Community
Feedback Session

Street End Design Meeting #2

March 25, 2026

Use Diagram: Building Offsets for Seating

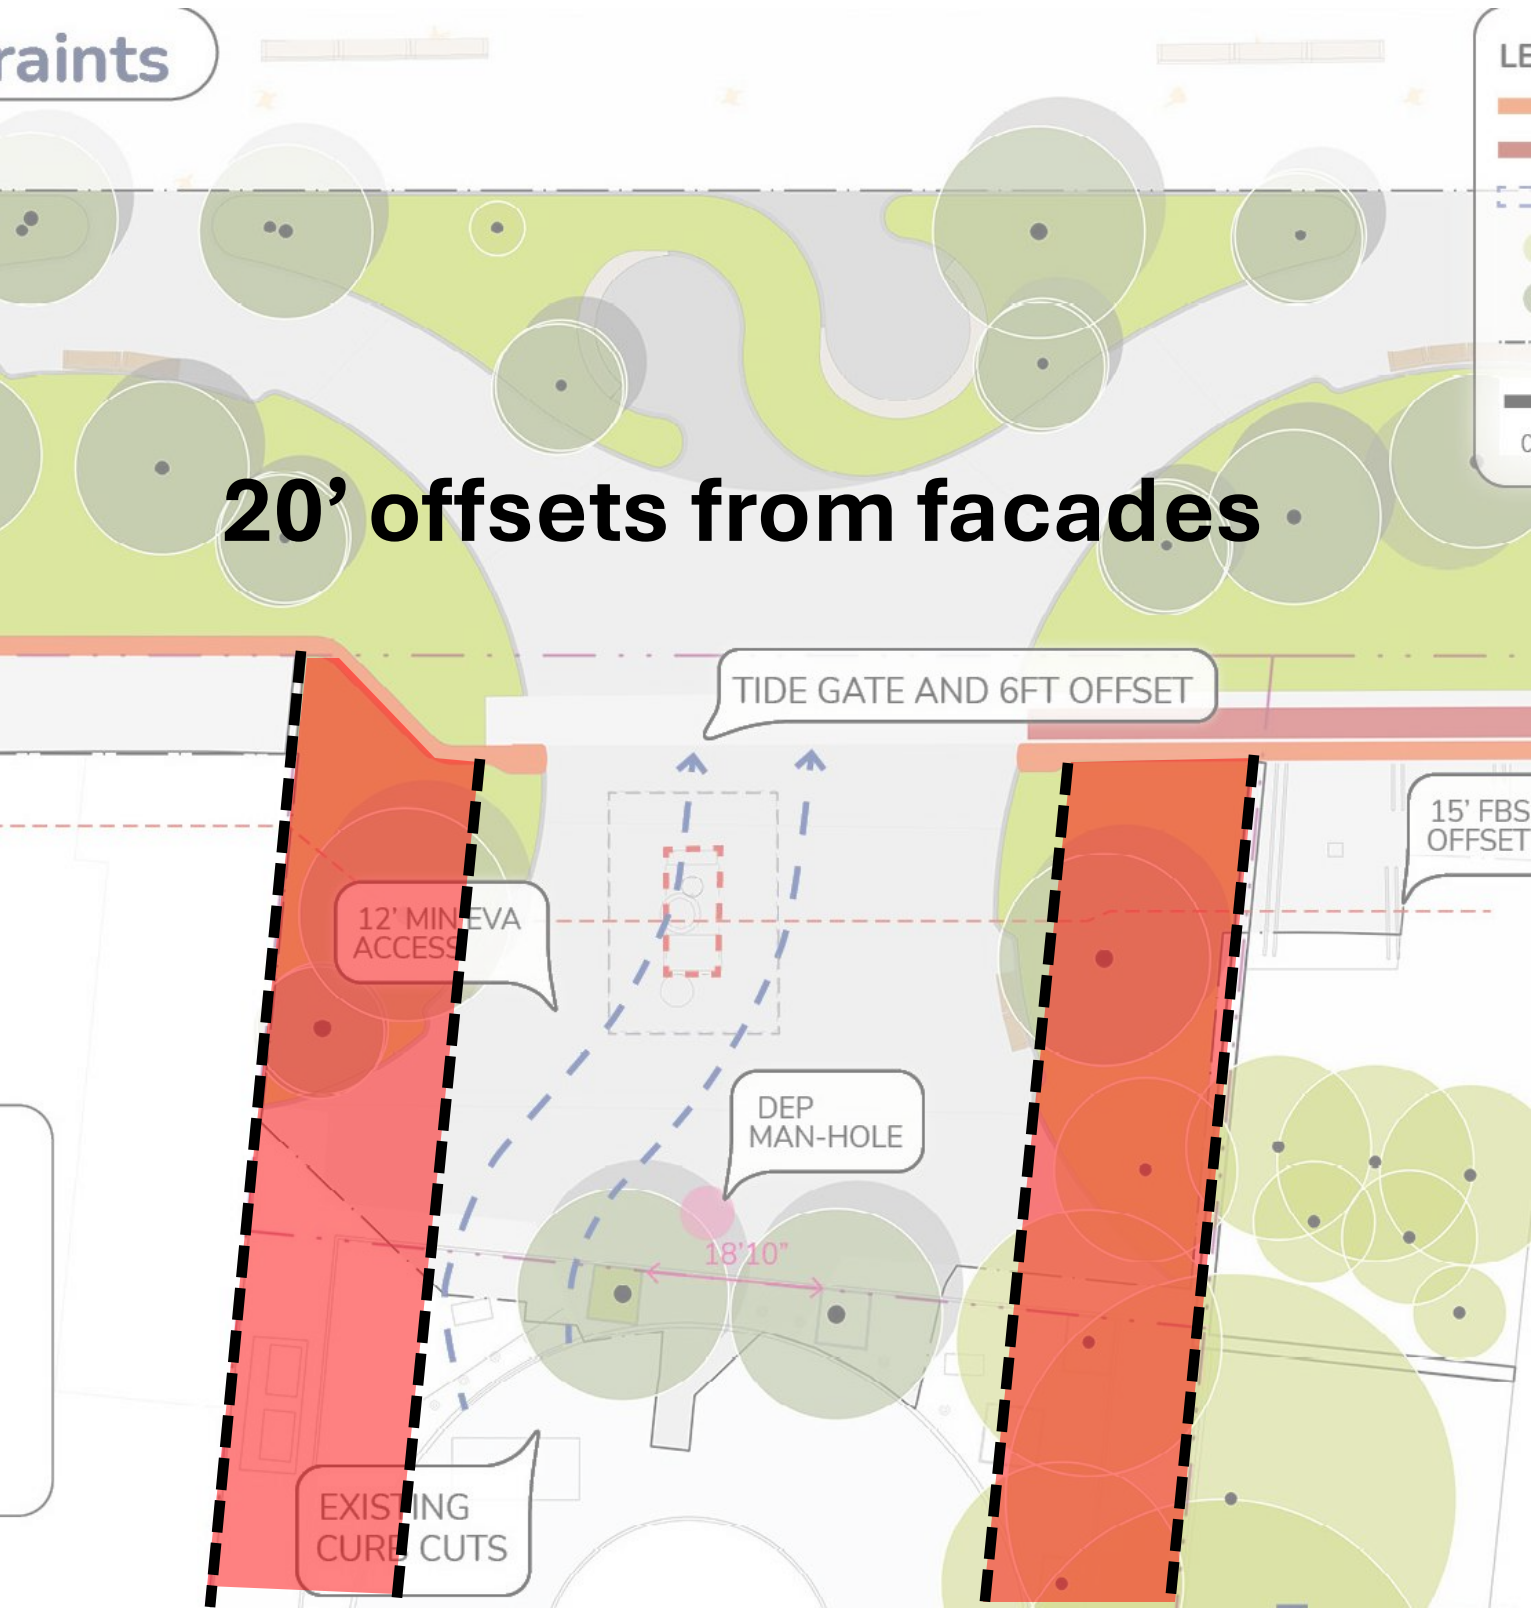
- Preference for **open, simple street end design**
- Offset seating and public spaces **at least 20' from residential facades (57%)**
- Support for both **straight and asymmetrical layouts**

Existing Seating at Albany Street is too close to Hudson Tower

- Openness in the center with views to the Esplanade, and **seating to the side, offset from buildings**

Use Diagram: Landscaping and Shading

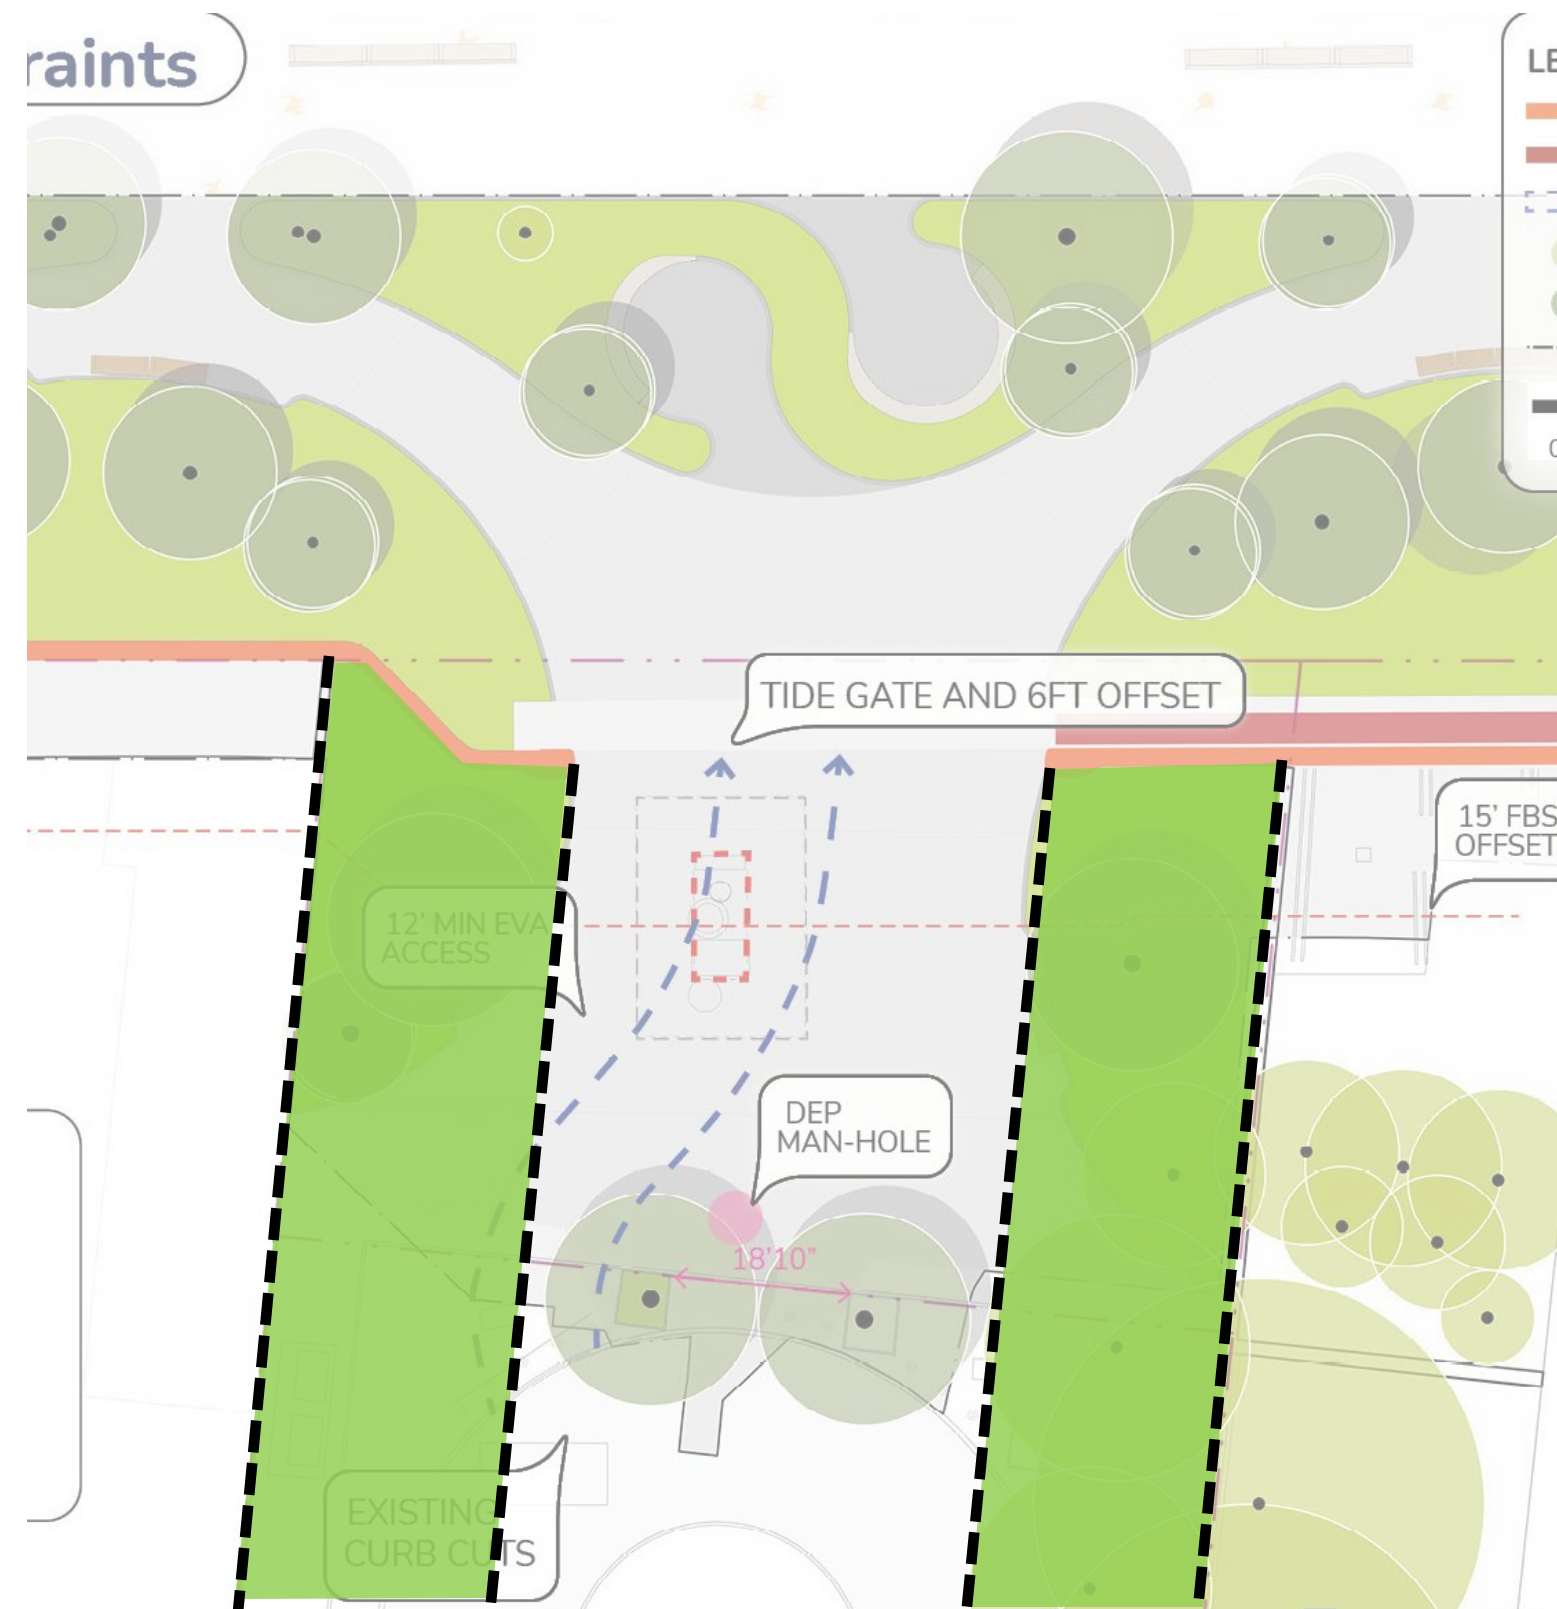
- **Flowers (76%), Trees (70%), Bushes (63%), Lower Plantings (56%),** not Planters (13%)
 - "We would like **as much natural shade from trees as possible**. We do not want umbrellas or artificial shade that do not fit neighborhood character."

- Landscaped areas will incorporate **flowers, bushes, and trees** where possible given constraints
